Docket Number: 24-SB-605

Comments on the SB 605 Draft Consultant Report on Sea Space Analysis

Subject: Comments on the SB 605 Draft Consultant Report on Sea Space Analysis

Fig. 1: Co-location of offshore wind and wave farms sharing balance of plant but in independent permit and area.

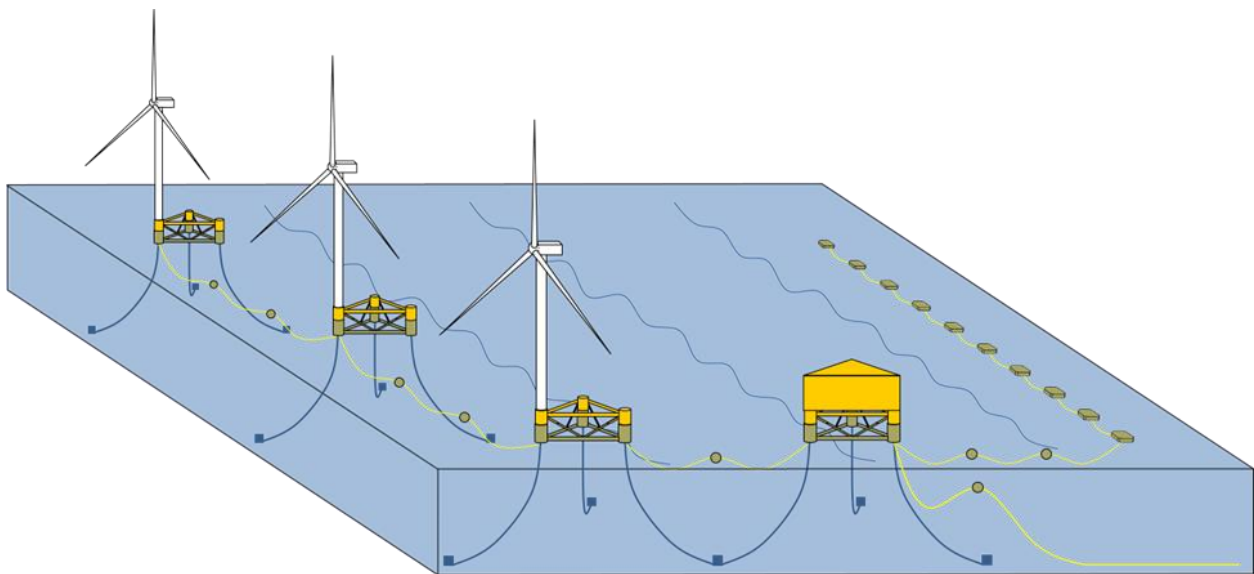
Page 45: We have two separate comments with regard to “Colocation With Offshore Wind Infrastructure.”

- 1) The report states that “The land-based and nearshore components of marine energy and wind energy operations could be colocated, potentially reducing the overall spatial and visual impact of that supporting infrastructure.”

These are relevant benefits of colocation, but the more critical and relevant opportunities are the shared utilization of balance-of-plant including on and offshore substations. This has the opportunity to:

2) The report states that “all wind energy lease areas are in medium-high wave energy areas, meaning there is resource potential for colocation of electrical cable connections or integration of WECs either into the turbine platform infrastructure itself or in the area within the turbine arrays.” We would like to highlight the point that all five BOEM offshore wind leases (two in Northern California off the coast of Eureka and three in South-Central California off the coast of Morro Bay) have significant wave energy resources. However, it is important to recognize the difficulty of integrating into the floating wind platforms themselves, especially given that floating offshore wind platform OEMs are still early in their growth phases as well. The most likely scenario may instead be that some offshore infrastructure is shared, like substations, export cables, and potentially even anchors.
